DEVELOPMENT APPLICATION ASSESSMENT REPORT

Application Number:	DA2024/1552	
Responsible Officer:	Olivia Ramage	
Land to be developed (Address):): Lot 108 DP 12749, 11 Florence Terrace SCOTLAND ISLAND NSW 2105 Lot LIC 643012, 11 Florence Terrace SCOTLAND ISLAND NSW 2105	
Proposed Development:	Alterations and additions to a dwelling house	
Zoning:	C3 Environmental Management	
Development Permissible:	Yes	
Existing Use Rights:	No	
Consent Authority:	Northern Beaches Council	
Land and Environment Court Action:	No	
Applicant:	Shed Architects Pty Ltd	
Application Lodged:	14/11/2024	
Integrated Development:	No	
Designated Development:	No	
State Reporting Category:	Residential - Alterations and additions	
Notified:	22/11/2024 to 06/12/2024	
Advertised:	Not Advertised	
Submissions Received:	1	
Clause 4.6 Variation:	Nil	
Recommendation:	Approval

PROPOSED DEVELOPMENT IN DETAIL

Figure 2 - Western elevation showing envelope breach in red

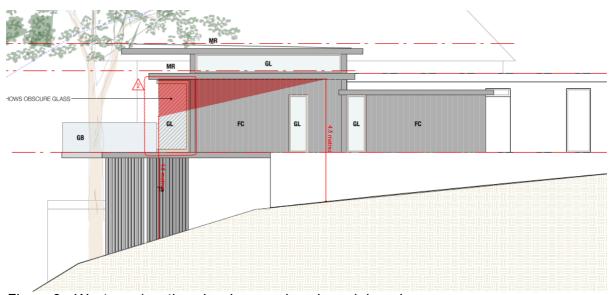
This control requires development to be sited within a building envelope determined by projecting planes at 45 degrees from a height of 3.5m above ground level at the side boundaries. The proposed development encroaches the western side building envelope as shown below.
